# PlanGrid Task Report - Jan 10, 2025

# #593 [UNIT 999][EXIST] (MISC) RTU-3 alarm

Pic 4  
**Aubrey Devonshire**  
Jun 19, 2024 7:30 AM

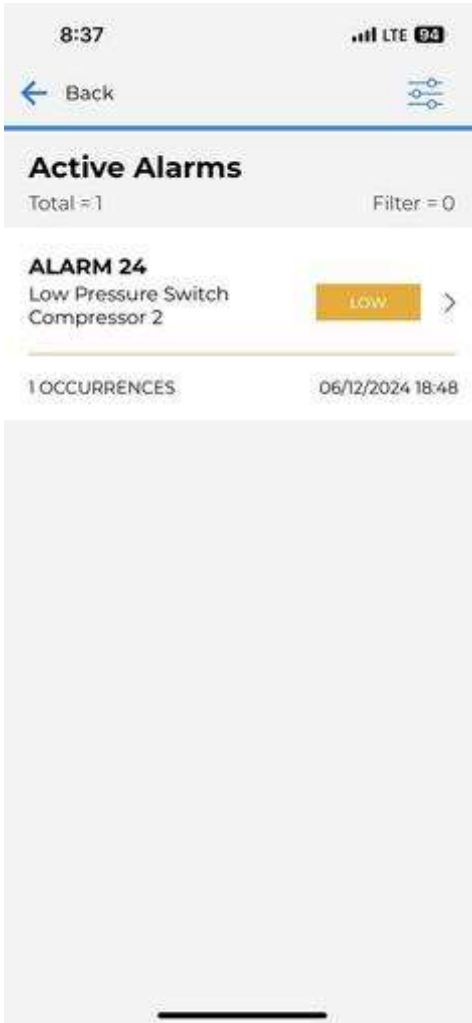
AC-3 has an active alarm. The alarm is (24) Compressor 2 low pressure switch. MC to evaluate and fix as required.

Task re-opened. AC-3 is a Lennox core unit. picture attached is a Lennox Prodigy board. Verify AC-3 core app is not showing any alarms.
